Official Transcript of Proceedings
NUCLEAR REGULATORY COMMISSION

Title: Advisory Committee on Reactor Safeguards
 Plant License Renewal Subcommittee

Date: Thursday, September 20, 2018

This is the meeting for the River Bend Unit 1 License Renewal Application. This meeting is a meeting of the ACRS Plant License Renewal Subcommittee.

Standby Diesel Crankcase Vent

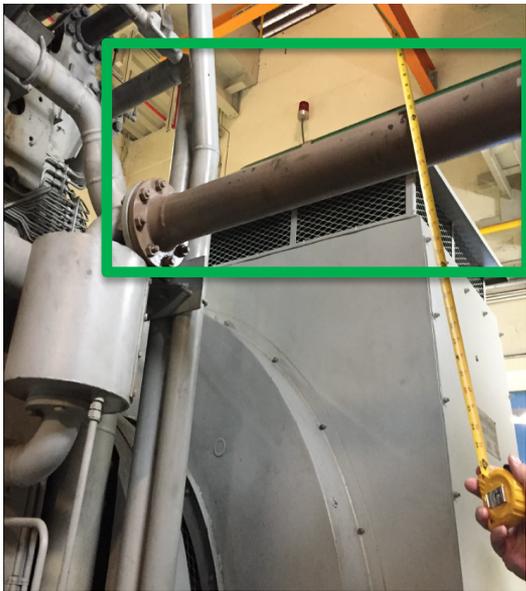
- RAI response 2.3.3.16-1 & SER page 2-50
- ACRS raised question on wording of RAI response
- Agree wording is misleading – RAI supplement planned to clarify
- Aging effects would not prevent venting

1 MR. YOUNG: Based on the comments that
2 you've provided and the statement in the SER, we're
3 preparing a supplement to that RAI response. And we
4 agree that venting of the subject diesel generator
5 crankcases is necessary. The original RAI response
6 should have more clearly stated that the vent line
7 intended function was to vent the crankcases outside
8 the diesel rooms.

17 MR. YOUNG: Right. And therefore, we will
18 be submitting an RAI supplement to the NRC staff to
19 remove the statement that the crankcase venting is
20 unnecessary.
